Mated Test Fixture Insertion Loss Comment #149

July 2026

Jason Ellison, Howard Heck, Joseph
Chen, Nathan Tracy, Marva Dar - TE
Connectivity

Provide supporting content for D3.1 comment #149 which addresses MTF insertion loss.

Straw Poll #10

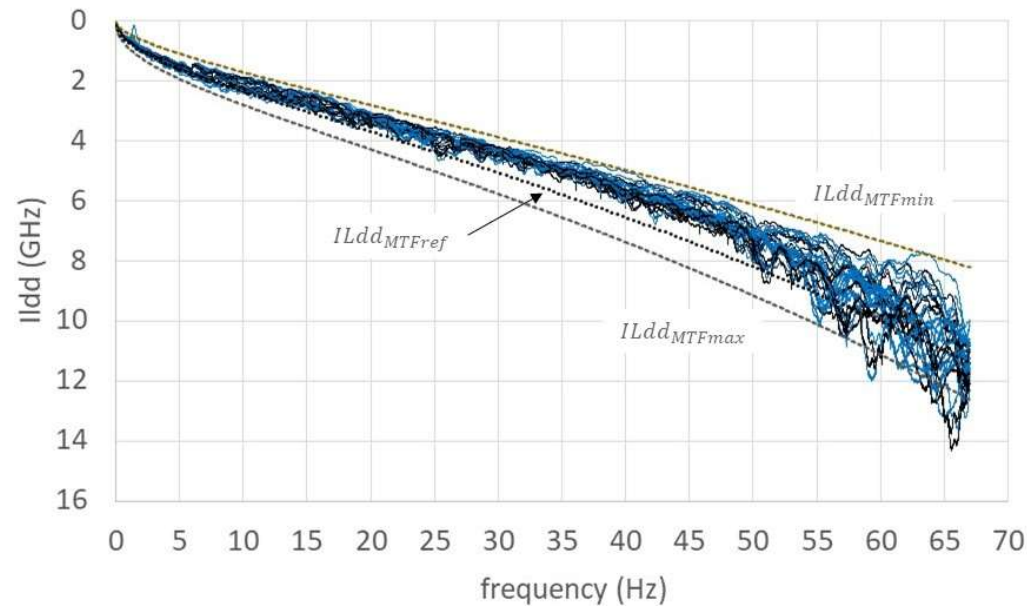
For the change to the Mated Test Fixture ILdd specification, I prefer the approach of:

- A> no change needed
 - B> fitted ILdd mask
 - C> more details on de-embed/re-embed process included in the draft
 - D> B plus C
- (choose one)

Results: A: 10 , B: 8 , C: 8 , D: 27
